CONSTRUCTION OF THE HWY 14 SENIOR/COMMUNITY CENTER

IFB#2018-0238-PW/IC

ADDENDUM No. 3

A5.4

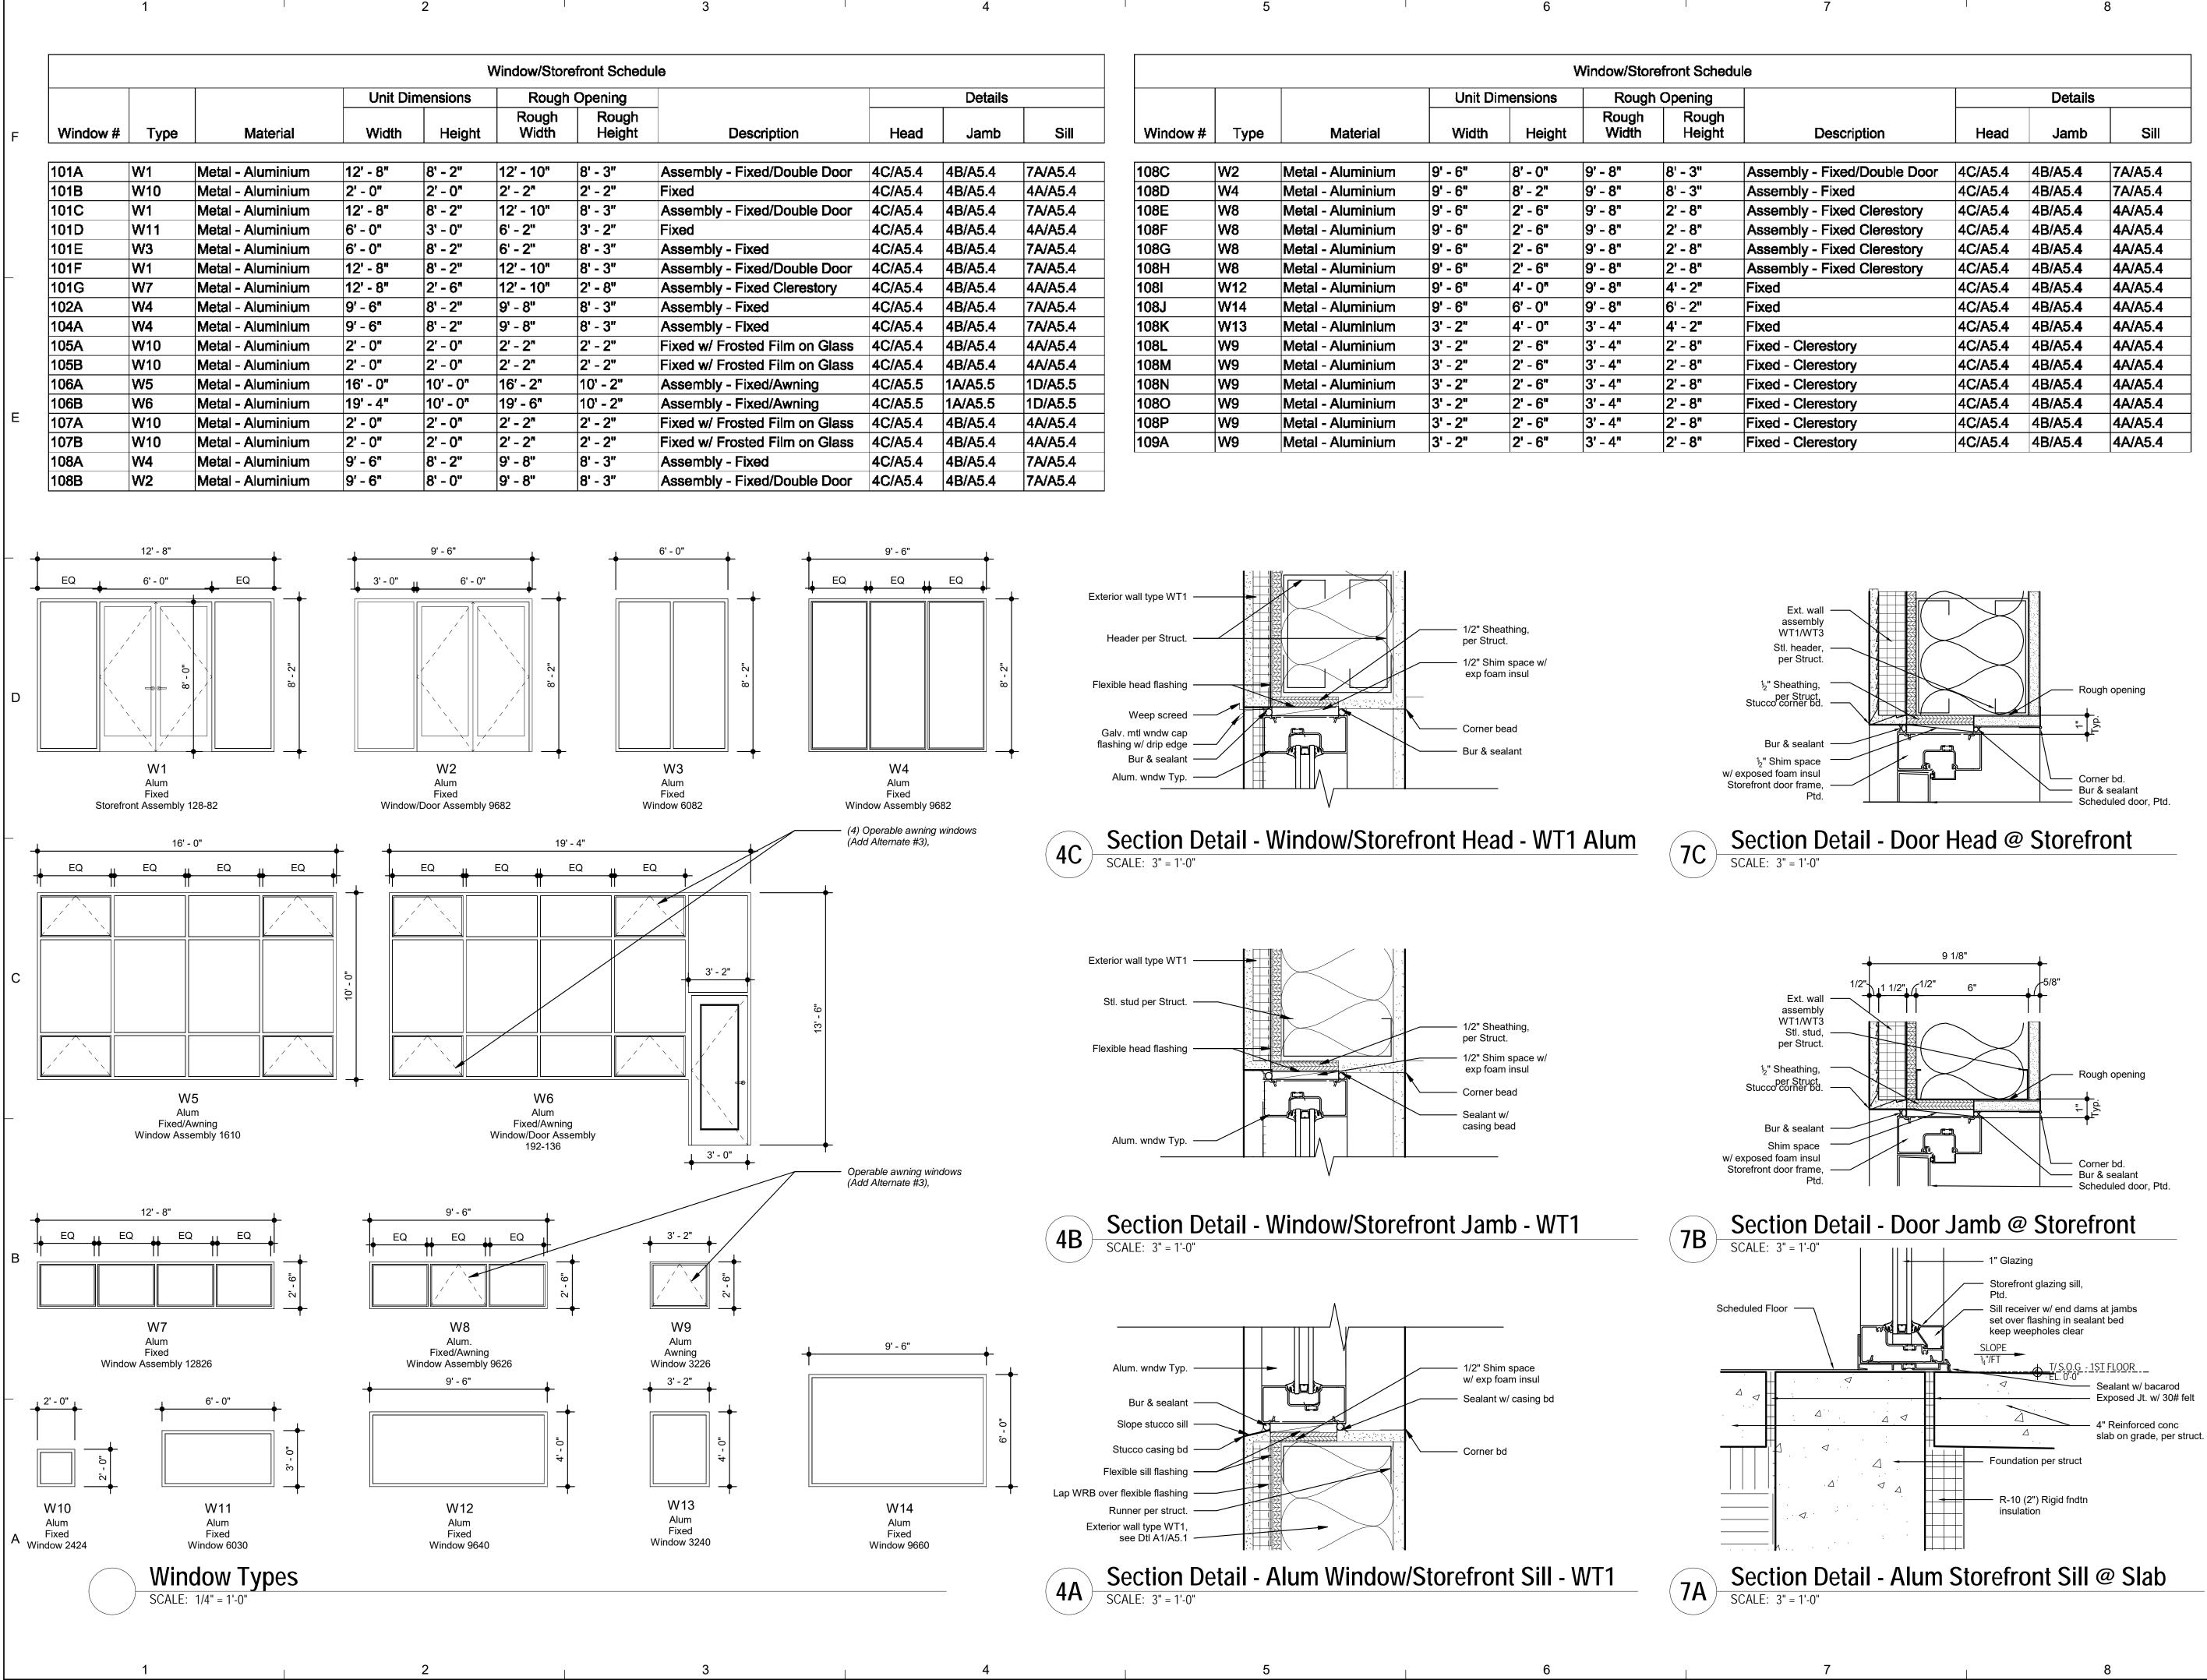
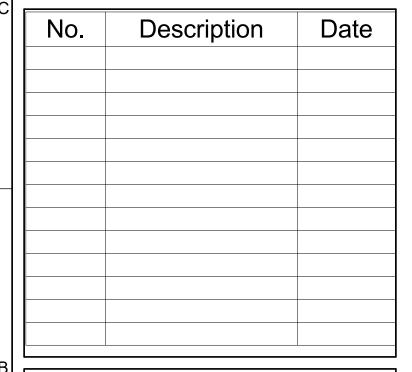
- Question 5: Please provide the Conduit size from the exterior telephone box to the interior telephone/data board?
- Response 5: 2 inch conduit. This response was incorrect, the correct response is 4" conduit.
- **Question 1:** What is the budget for this project?
- **Response 1:** The County has a budget of \$1.6 million exclusive of GRT.
- **Question 2:** There are four window types we cannot find on the elevation sheet, A2.1, and floor plan, A1.1. types 108Q, 108R, 108S and 108T. Types 108R and 108T show up on sheet A1.2, floor plan alternates, but this does not agree with the elevation sheet A2.1. Are these four windows to be deleted from the scope or are they hidden?

Response 2: Delete from Scope (see attached drawing A5.4 – Window Schedule)
